Revision of Clauses 22.4.1 A1, A2, A3 and A4 and 22.4.3 A3, Draft HIPS 2013

Background

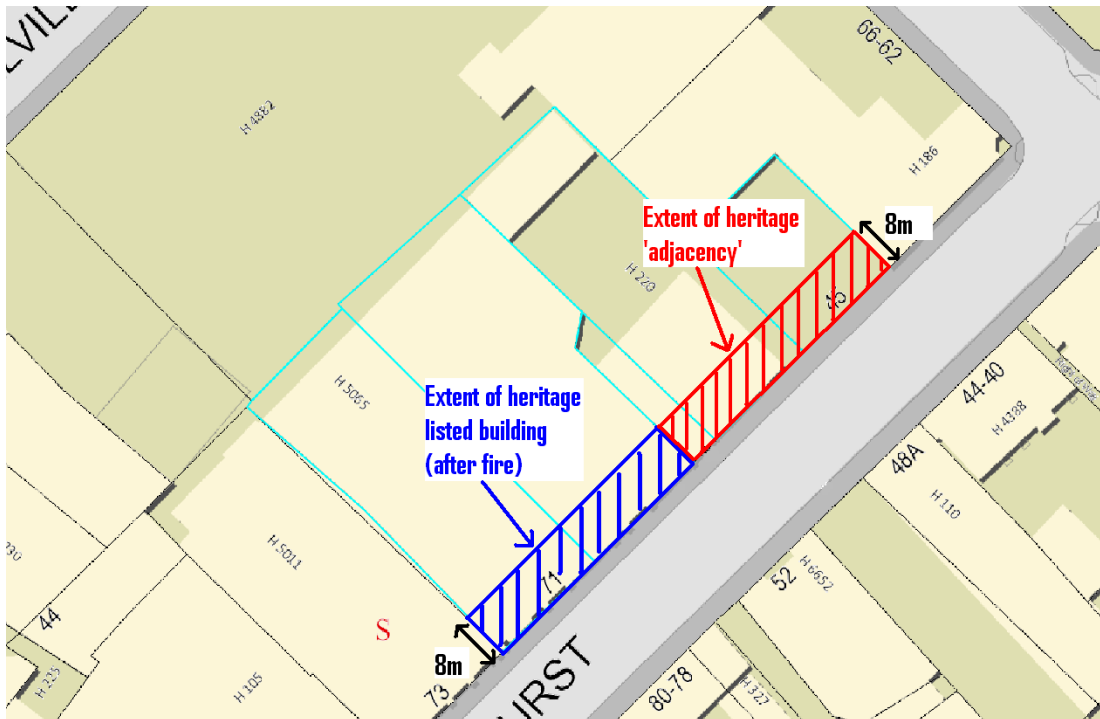
- Heritage adjacency provision covering the whole area forward of the rear building line of the adjacent heritage building (as shown below). This scenario reflects how the provision would be interpreted as originally drafted for the consultation version of the HIPS 2013.

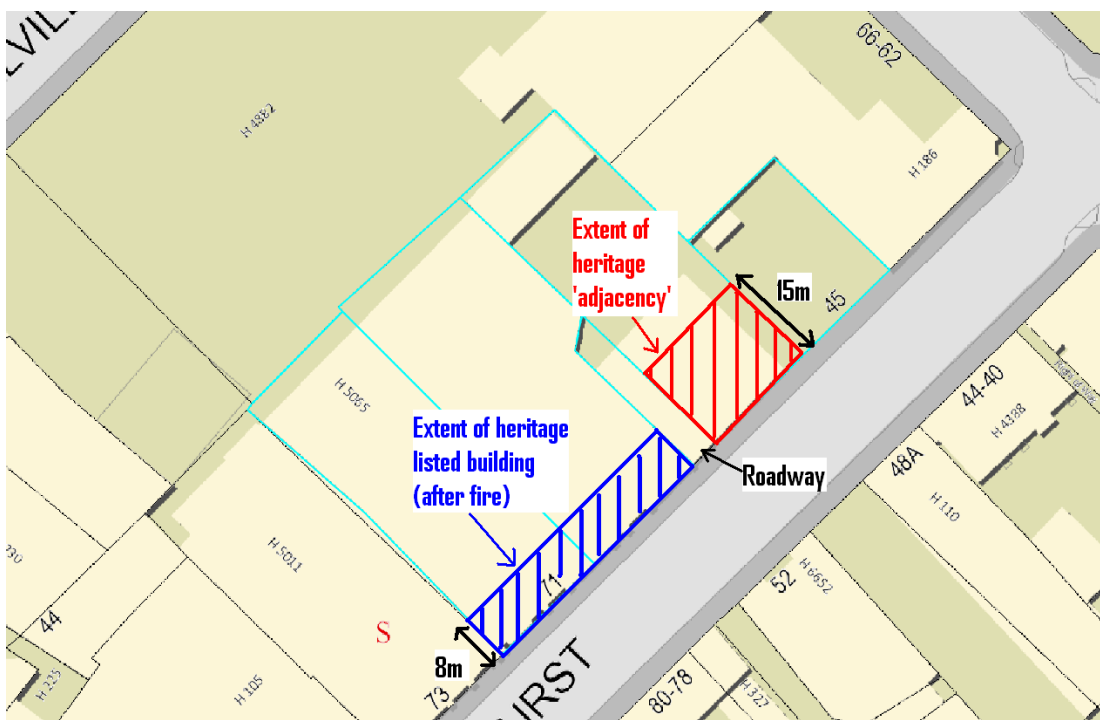
- Heritage adjacency provision covering the whole area forward of the rear building line of the adjacent heritage building, and all lots amalgamated (as shown below). This scenario reflects how the provision would be interpreted as originally drafted for the consultation version of the HIPS 2013, IF the lots were all to be amalgamated.

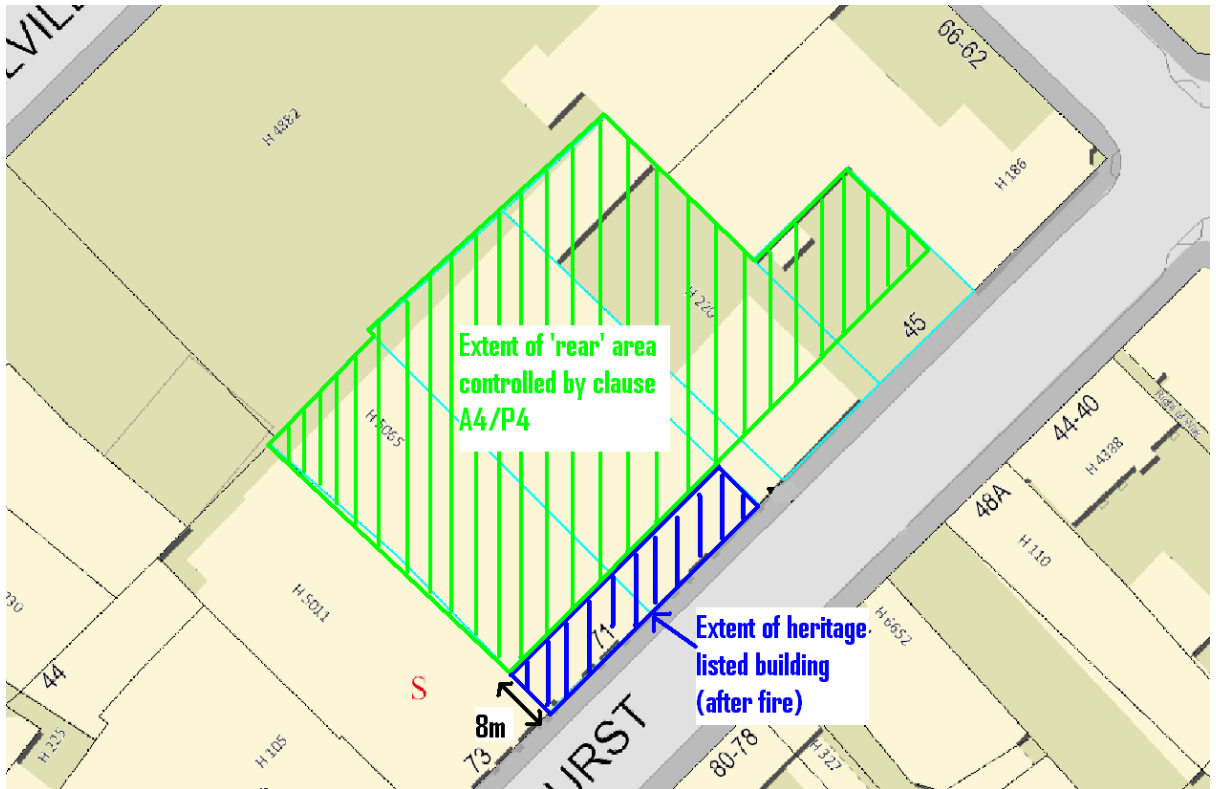
- Heritage adjacency provision covering the first 15m from the frontage (as shown below). This scenario reflects a preferred interpretation that addresses the first 15m of a site adjacent to a heritage building (refer to discussion below under 'Provisions for height adjacent to a heritage building').

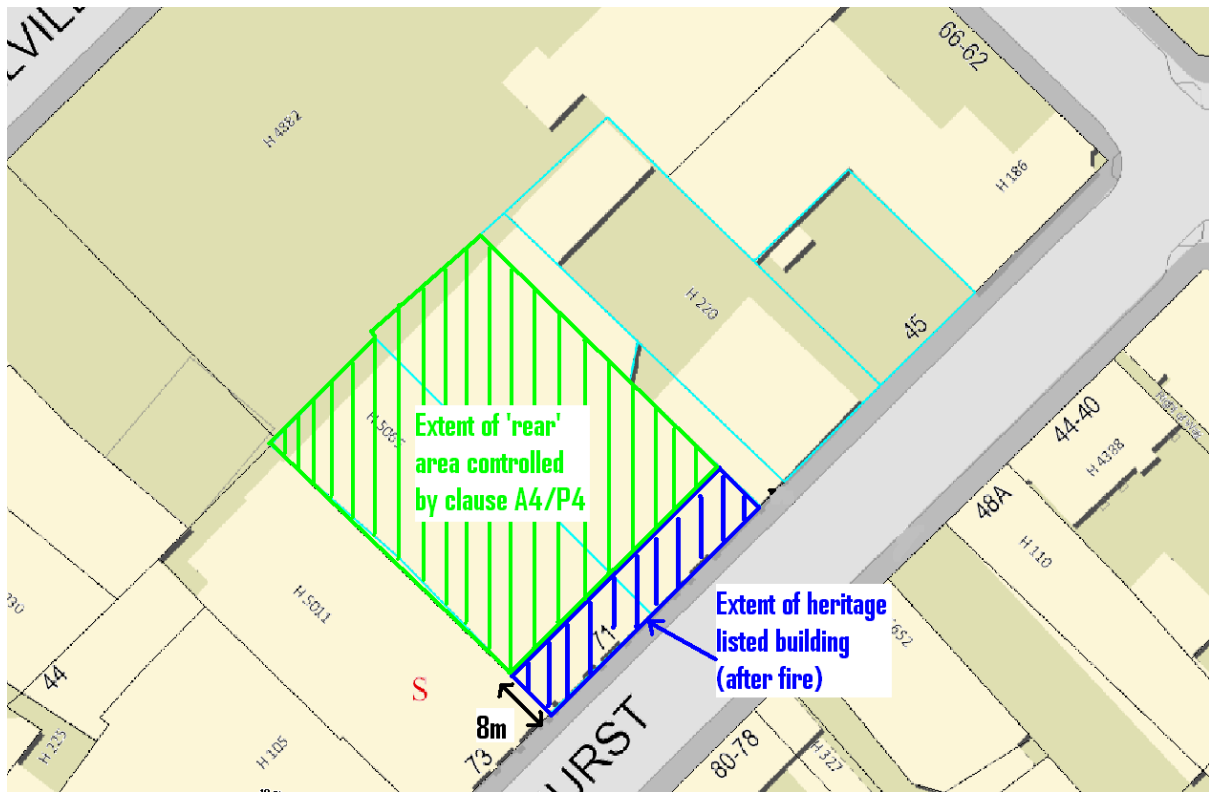
- Development to the rear of a heritage building provision relating to **all** of the area behind the heritage building, with all titles amalgamated (as shown below). This scenario reflects how the provision would be interpreted as originally drafted for the consultation version of the HIPS 2013, IF the lots were all to be amalgamated.

Note: If the lots were not amalgamated in this instance, the extent of the area to which A4/P4 apply would be limited to the two lots containing the heritage building.
